DEFENSE NUCLEAR FACILITIES SAFETY BOARD

Staff Report

Review of the Savannah River Site Fire Protection Program

Figure 2. Error in fire door inspection checklist (red circled areas)

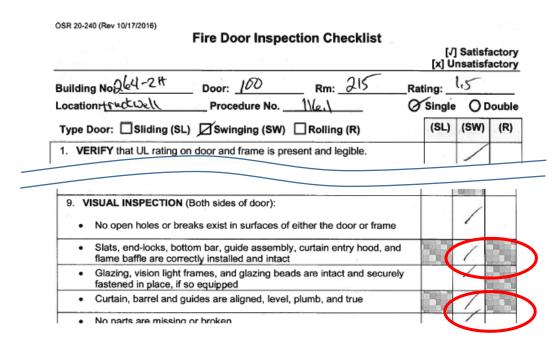
The fire door inspection checklist form (OSR 20-240) attached to the 2016, 2017, and 2018 TEF fire door inspection records contains an error [18, 19, 20]. Specifically, two of the visual inspections for rolling fire doors are incorrectly blocked-out, which promotes incorrectly marking these items as the wrong type of door (see figures 2 and 3). For all of the inspected doors in the 2017 and 2018, inspectors incorrectly checked "satisfactory," similar to figure 2. Conversely, for most of the inspected doors in 2016, inspectors correctly marked "N/A," despite the error in the checklist.
